Re: Drainage & Grading Plan
Windward Investments
Lot 1, Block A, Interstate
Industrial Tract

Re: REVISED DRAINAGE REPORT - LOT 1, BLOCK A, INDUSTRIAL TRACT

Re: Revised Drainage Report
Lot 1, Block A Interstate
Industrial Tract
F.D. Job No. 463.21

REVISED
DRAINAGE MANAGEMENT STUDY
LOT 1 - BLOCK A
INTERSTATE INDUSTRIAL TRACT

EXHIBIT E

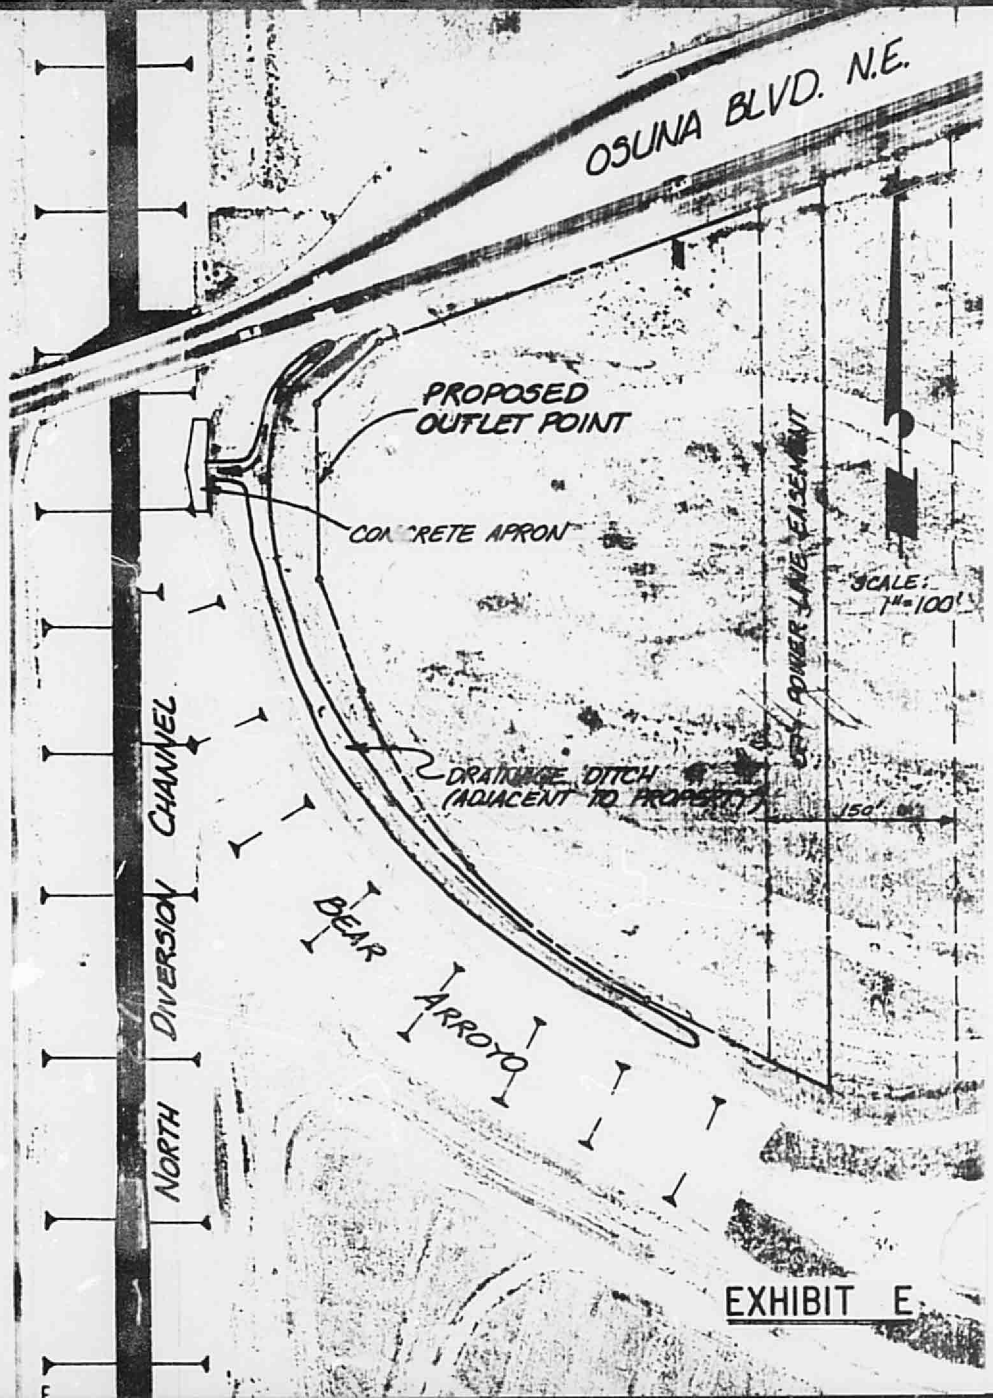
35.12 cfs will be introduced into the North Diversion Channel via the small drainage ditch which runs adjacent to the Parcel's Western Property Line (see Exhibit E).

EXHIBIT B

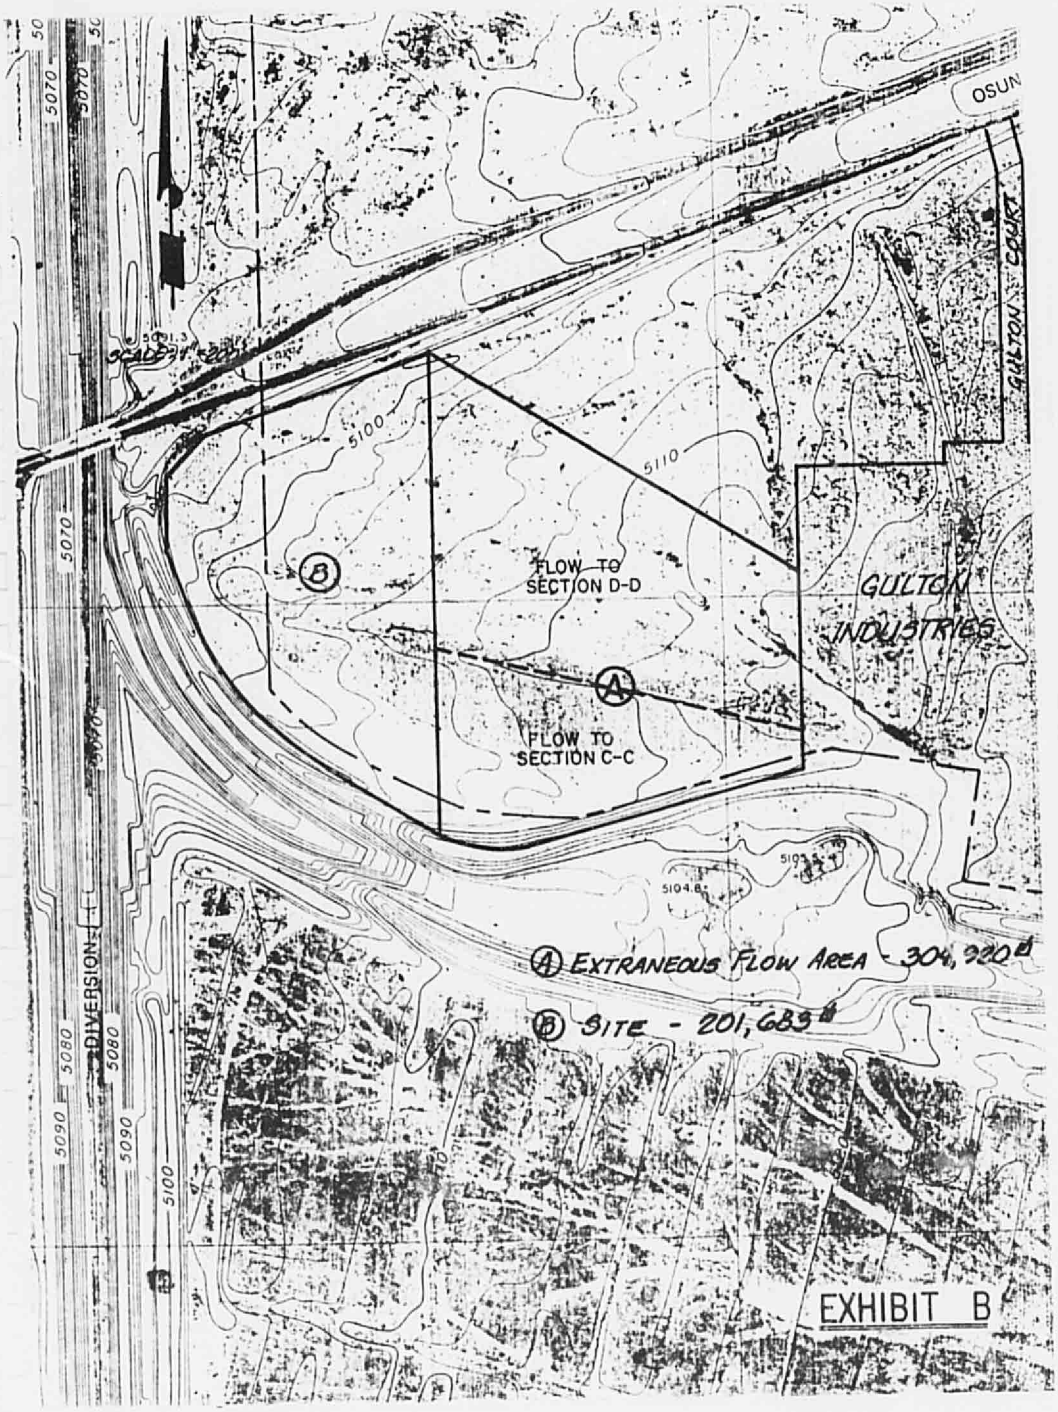
As shown on Exhibit B an area consisting of approximately 7.0 undeveloped acres drains from east to west and is introduced onto the site.
